RAI Volume 3, Chapter 2.2.1.3.6, First Set, Number 6, Supplemental Questions:

1. SUPPLEMENTAL RESPONSE

Figure 1. Comparison of Base Case and Alternative (Case 6c) Cumulative Flow Focusing Distributions

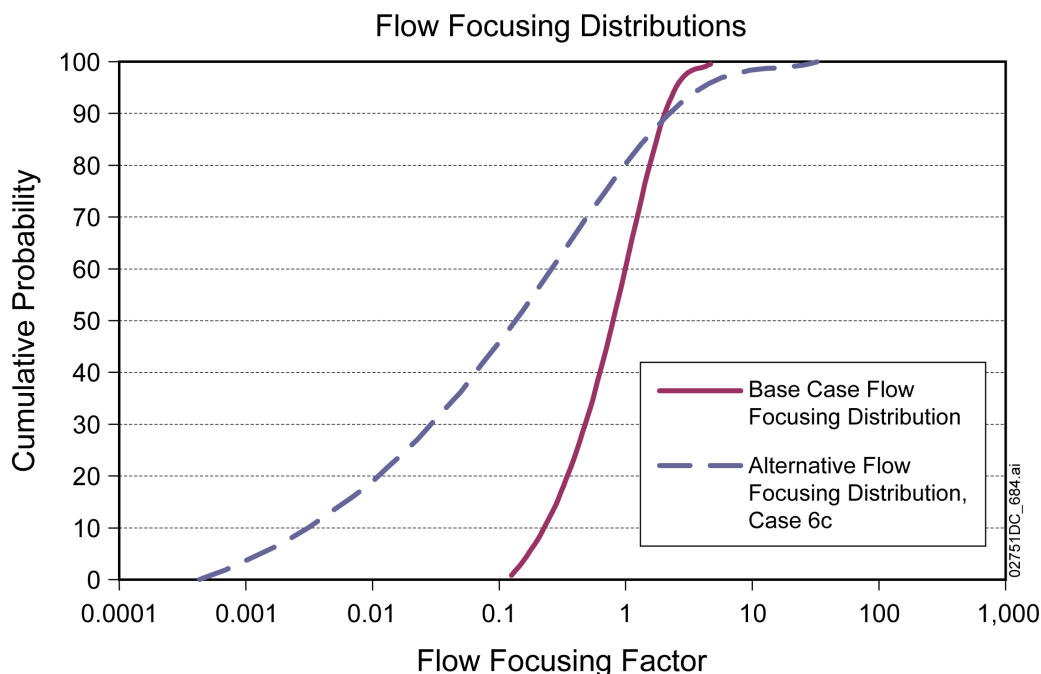
1. As stated in the response to RAI 3.2.2.1.3.6-006, an alternative representation (Case 6c) of flow focusing leads to an increase in mean seepage rate by a factor of 3.3 compared to the nominal distribution of flow focusing.
 - a. What is the answer to the second part of the RAI, i.e., what is the performance consequence of this factor increase?
 - b. Describe the distribution (mathematically) and the basis for the flow focusing factor for Case 6c, which is possibly the same as used in *Abstraction of Drift Seepage*, MDL-NBS-HS-000019 REV 1, AD 01, Section 6.8.2, Case 6.
2. Describe why performance is insensitive to seepage fraction.

The flow focusing distributions for the base case and Case 6c are compared in Figure 1. When such distributions are manipulated to extend the range of focusing factors that are greater than 1, but are constrained to maintain a mean of 1, the frequency of focusing factors less than 1 must also increase. As shown in Figure 1, the probability of a flow focusing factor less than 1 is 60% in the base case as compared to 80% in Case 6c.

The maximum flow focusing factor, 33, for Case 6c lies within the range of the three distributions discussed above. The distribution function for Case 6c (Equation 1) was developed as a representation of such broad focusing distributions for use in the sensitivity analysis (SNL 2007a, Section 6.8.2). The base case flow focusing factor distribution is derived from a process-level description of unsaturated flow representing the effects of small- to intermediate-scale heterogeneity in fracture permeability. By comparison, the flow focusing distribution developed previously as discussed above is a less direct method to estimate flow focusing. Therefore, the alternative flow focusing distribution used in Case 6c is only suitable to investigate the sensitivity of the seepage abstraction to flow focusing, and is not representative of the physical system.

Figure 3. Comparison of Corrected Base Case TSPA Seepage Fraction Results Averaged over Aleatory Realizations, for the 1,000,000-Year Seismic Ground Motion Modeling Case, with Results Using the Case 6c Flow Focusing Factor

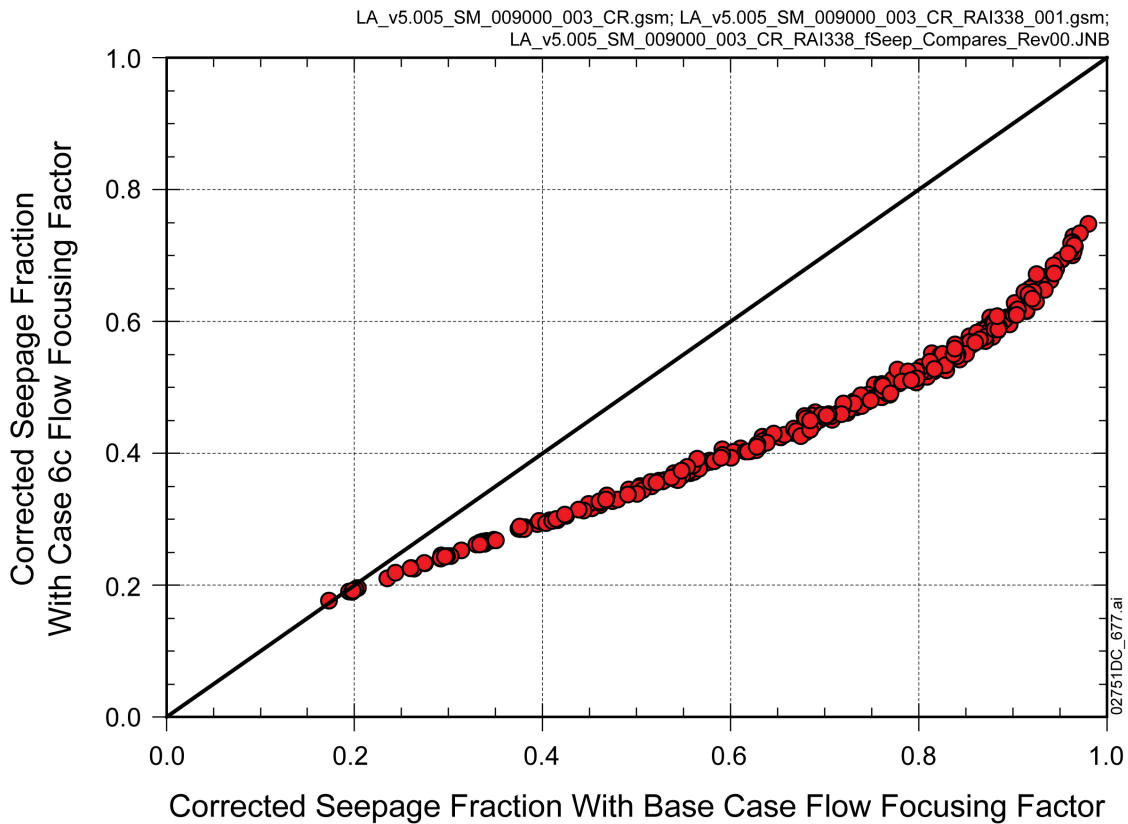
Section 1.4.2 of the DOE response to RAI 3.2.2.1.3.6-006 describes repository performance as insensitive to seepage fraction. Also, SAR Section 2.3.3.2.3.4.1 similarly describes a lack of sensitivity of performance to seepage fraction changes caused by increased waste package length. Given the insensitivity for performance, how does the decrease in seepage fraction for Case 6c offset the seepage increase (see Section 1.4.1 of the DOE response)?

The smaller seepage fraction that results from using the Case 6c flow focusing distribution, compared to the corrected base case, is shown in Figure 3. This figure compares the average seepage fraction (averaged over aleatory realizations) for each epistemic realization for the Case 6c flow focusing results with the corrected base case. The seepage fractions are uniformly smaller using Case 6c, for nearly all epistemic realizations.
